POWER SUBSYSTEM

Power supply	Michał Stomiany
Air Data Computer HAB V2	ADC_schematic
Rev A	07.01.2023 20:02
	Sheet: 2/3

MUX

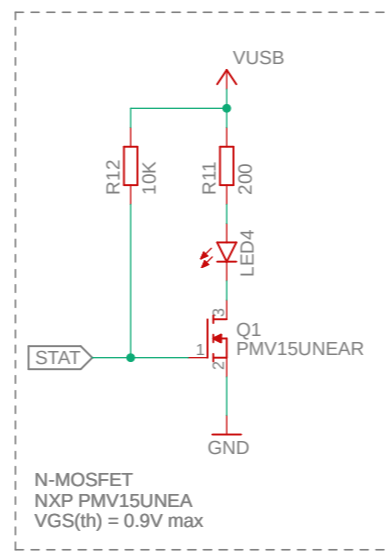
LED4 is ON when STAT is high
 It indicated that VOUT = VIN1
 IS IT A CORRECT DESIGN?
